TRAILWOOD APARTMENTS SR-87-2016

AA# 3582 Case File: SR-87-16 Trailwood Apartments

Case File / Name: SR-87-16, Trailwood Apartments

Request: Development of a 5.08 acre recombined tract zoned RX-3-PK CU and within both

SR-87-16 Preliminary Site Plan

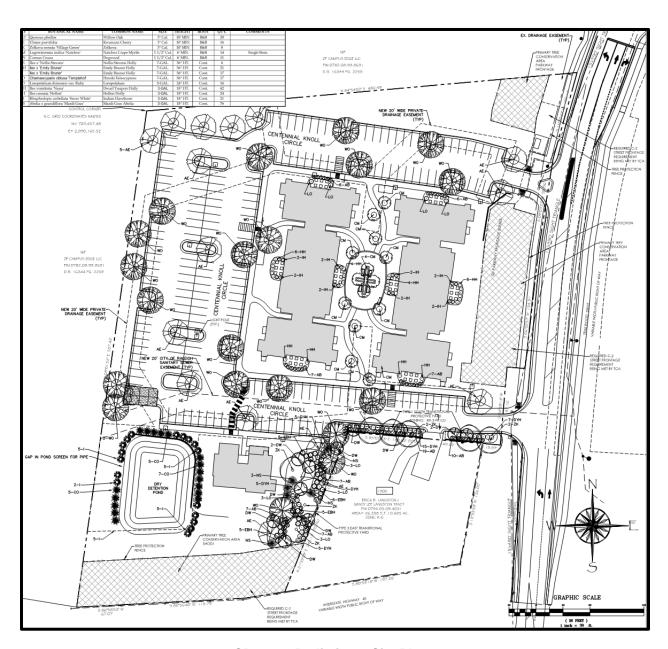
Administrative Alternate Findings:

The Planning and Development Officer may in accordance with Sec. 10.2.17. reduce the build-to requirement, subject to all of the following findings:

The approved alternate meets the intent of the build-to regulations

3. The approved alternate does not substantially negatively alter the character defining street wall or establish a build-to pattern that is

4. The change in percentage of building that occupies the build-to area or increased setback does not negatively impact pedestrian access, comfort or safety; and

5. Site area that would have otherwise been occupied by buildings is converted to an outdoor amenity area under Sec. 1.5.3.B.

Staff response: The project contains a building located within a range for building placement behind a vegetated buffer that supplements the existing street edge condition along Trailwood Drive. The alternate provides flexibility for the project's specific site design and allows the building to address Build-to regulations while also complying with the setback required by the Parkway frontage.

and adopted City plans; Staff response: The project conforms to several Comprehensive Plan policies, including LU 4.5, LU 5.1, T 2.9, T 5.10, and UD 5.1.

not harmonious with the existing built context; Staff response: The project does not negatively alter the character defining streetwall or establish a development pattern that is not harmonious with the existing built context. The heavily vegetated buffer of existing trees between the proposed building and the street will be similar to and reinforce the pattern of adjacent development to the north

Staff response: The proposed alternate does not negatively impact pedestrian access for the site. Sidewalks are provided from the buildings to the Trailwood Drive sidewalk along the two access driveways. A walkway, including a crosswalk across the northern driveway, also provides access to the bus shelter to the north of the site

Staff response: The area between the Parkway frontage buffer and the proposed building has been identified as outdoor amenity area. It includes the area within the Build to range specified by code.
